RECOMMENDATION FOR CONDITIONAL ZONING AT 710 North Estes

RECOMMENDATION N ESTES TOWNHOMES CONDITIONAL ZONING APPLICATION 710 N. ESTES DRIVE

Re: 710 N. Estes Drive Chapel Hill, NC (the “Property”)

CDC Summary of Comments re: 710 N Estes

Figure 4: North-South site section showing topography and unit stepping.

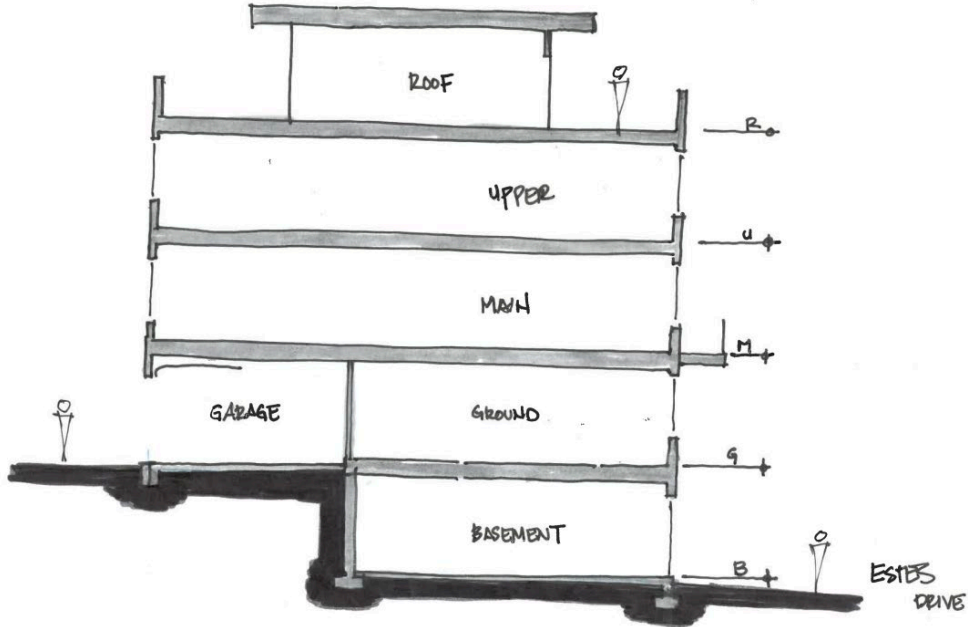
1. **Site design.** The proposed development is not well integrated with the existing topography. There is massive clear-cutting, and a 15' tall, public-fronting retaining wall will leave a table top effect. The design doesn't emphasize the pedestrian realm. Rather, it is the circulation of vehicles (cars, fire trucks, garbage trucks) that is dictating the site organization – not the shaping of outdoor spaces or the community experience. We also believe there is too much parking for a town that is emphasizing multi-modal transit and this close to a transit station at the corner of Estes and MLK.

- Townhomes in this location should allow the topography to inspire the architecture. This could break up the elevation and bring positive visual appeal to the site. See concept below image.
The existing topography has been studied thoroughly and additional efforts to match it more closely are in progress. Proposed townhomes already step up to 6' along certain rows. Steeper slopes will eliminate ADA accessibility within the community, which is required.

The renderings were inaccurate and did not accurately depict the way the buildings are stepped between each townhome to work with the topography. This is now correctly rendered. Additionally, the building along Estes has been redesigned with a split-level foundation to work with the slope and eliminate the table topping effect. These units now better interact with the proposed path and a ramp was added to bike from the site directly onto the path. The retaining wall in question is not public-fronting except for the corner (about 50') however it now terminates down to 0' height. It is screened heavily by the permanently protected stream buffer. Most of the wall along Aura is approximately 6-7' tall. Town staff had asked for more visitor parking after the 1st CZP submission. Since the CDC meeting, we have reduced the number of 2-car parking garages and eliminated 40 spaces. The parking count is 205 reserved spaces for 95 units (a 2.1 ratio) and 20 guest parking spaces. We are open to reducing the guest parking count if required, although we think the current count is appropriate. We have committed to 23 (or more) biking spaces, exceeding the requirement by a multiple of 5.
